## Addendum 01

Butler Area School District  
High School Roofing  
IKM Project #17-124.10

Drawings	Description
A100	-Scope updated PreBid sign in sheet

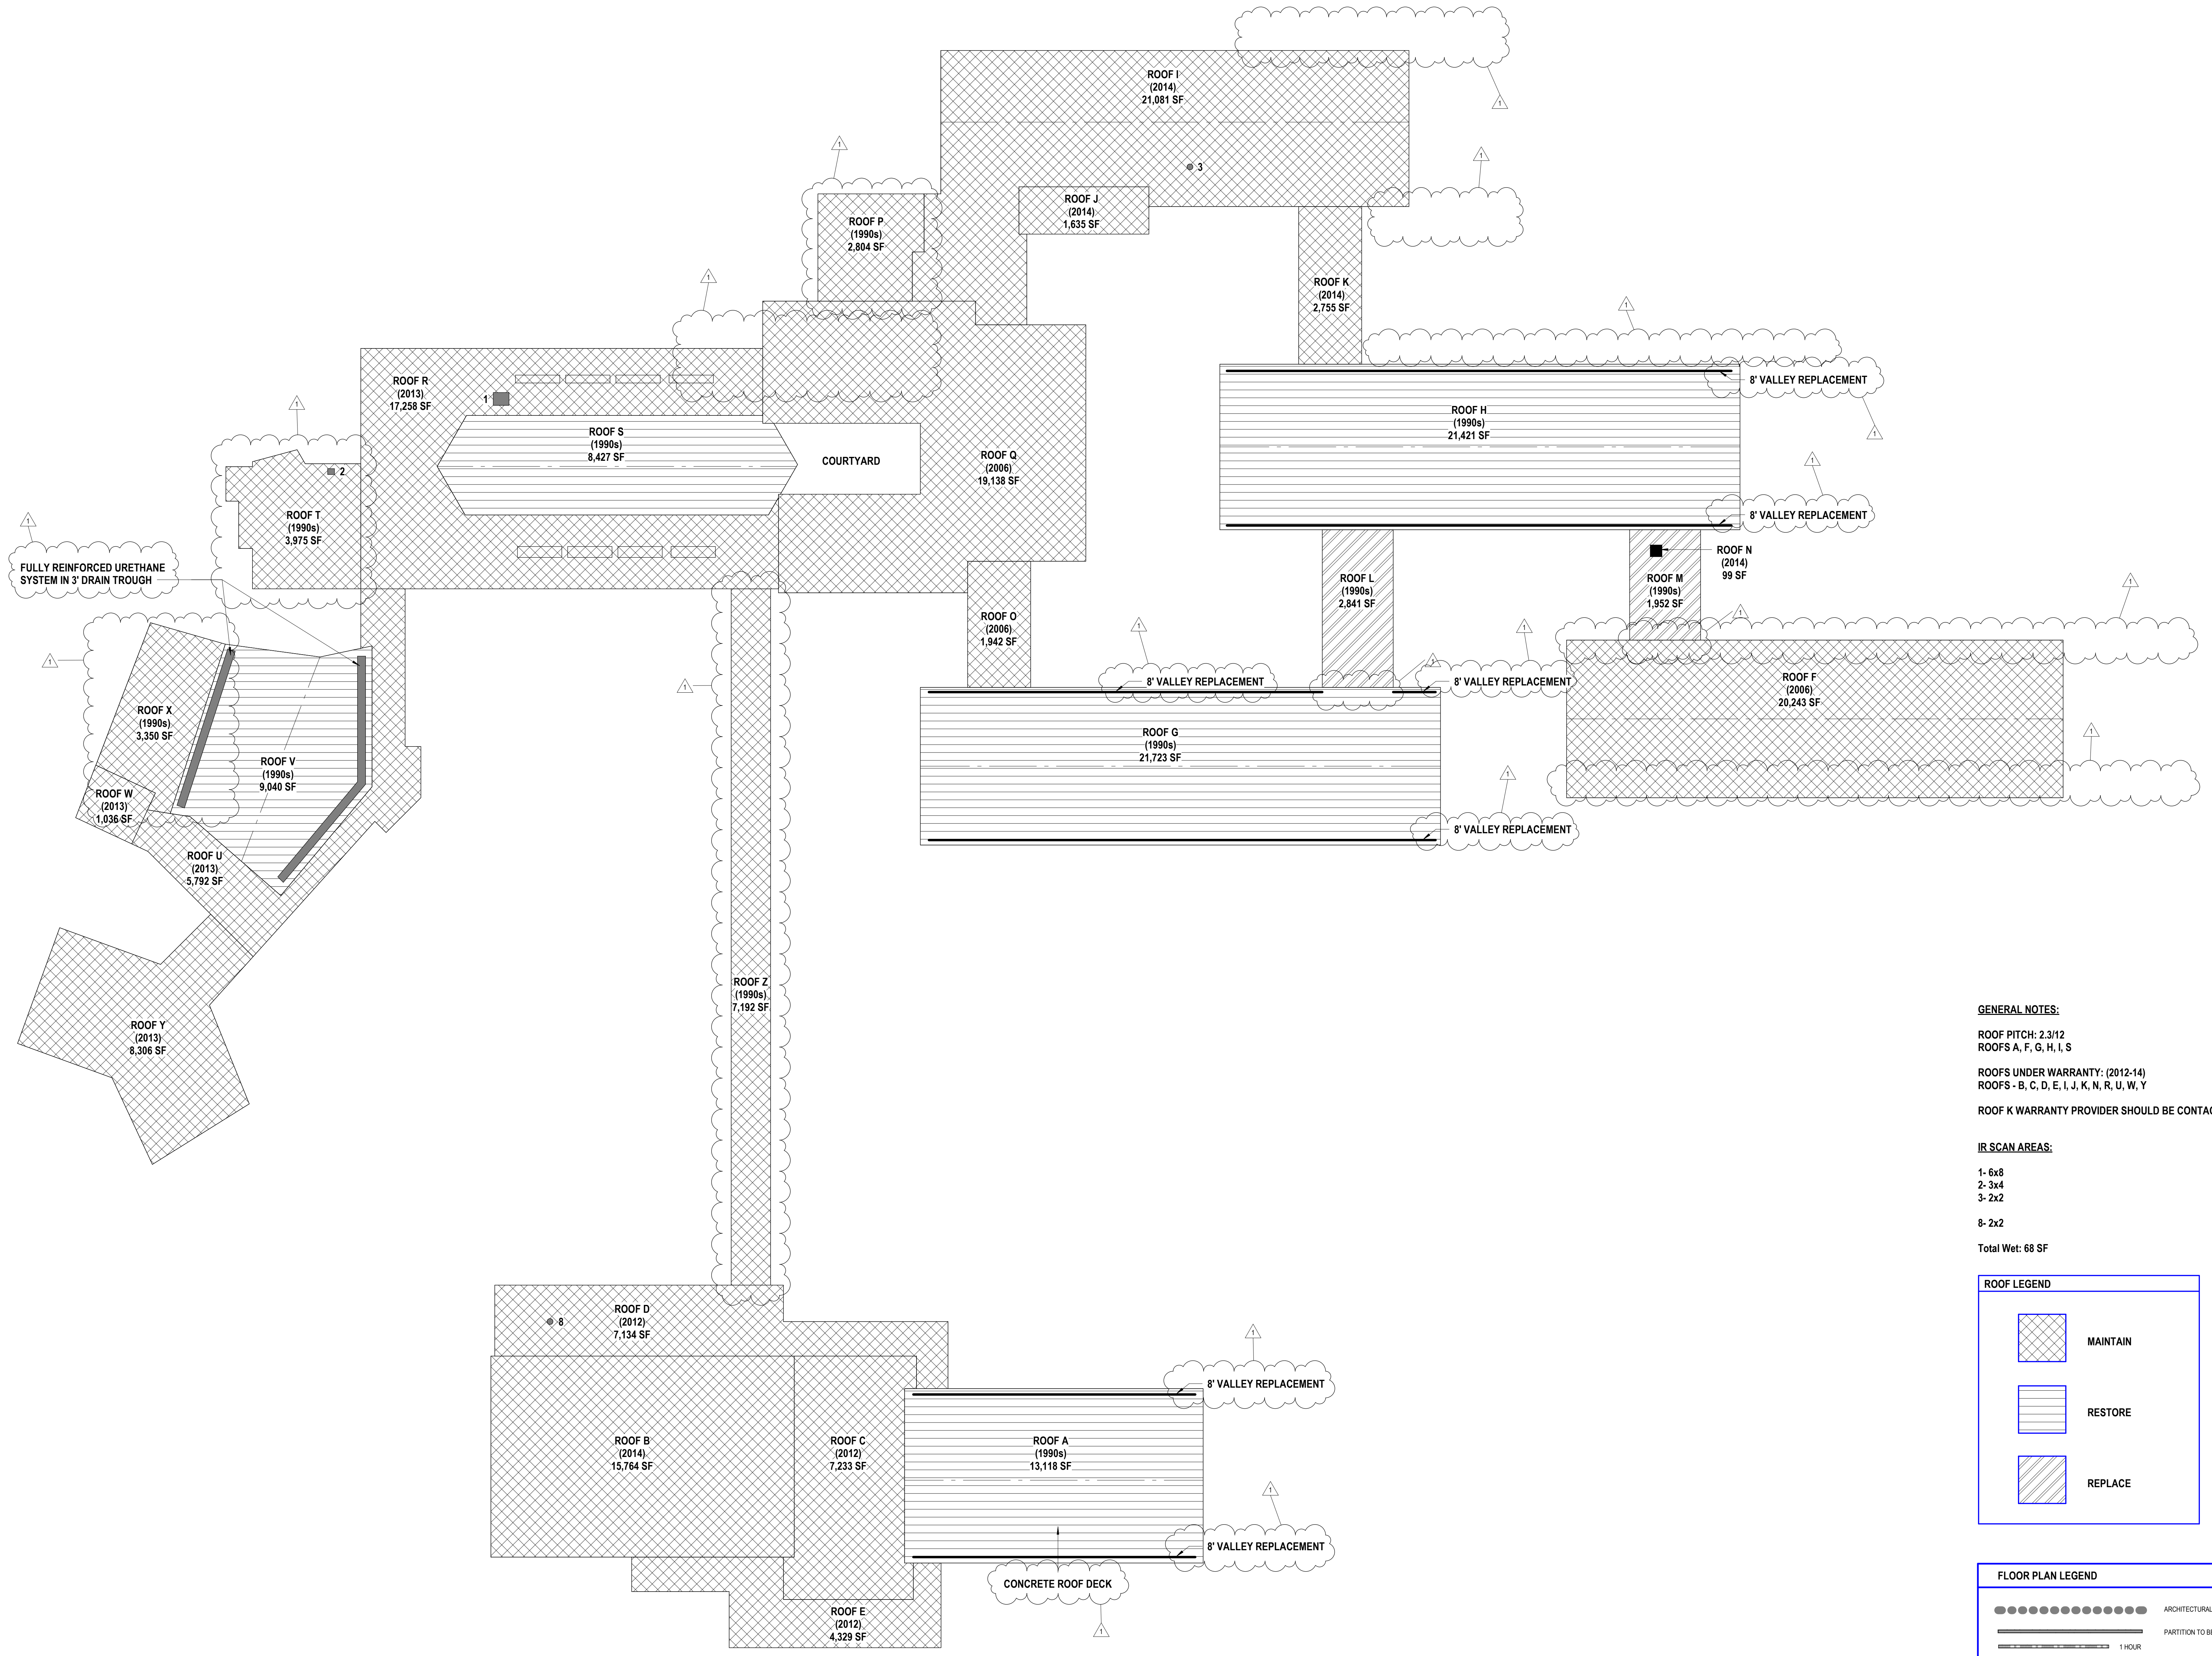
- 1.01 Please see revised drawing.
- 1.02 The insulation for the valley replacement on Roof A will be adhered in low rise foam insulation adhesive. No fastening to the concrete deck will be permitted on Roof A.

- 1.03 The drain trough on Roof V is to be fully reinforced with polyester fabric.
- 1.04 Roofs P, T, X & Z will be removed as replacements and no work will be performed on these sections. Please see revised drawing.
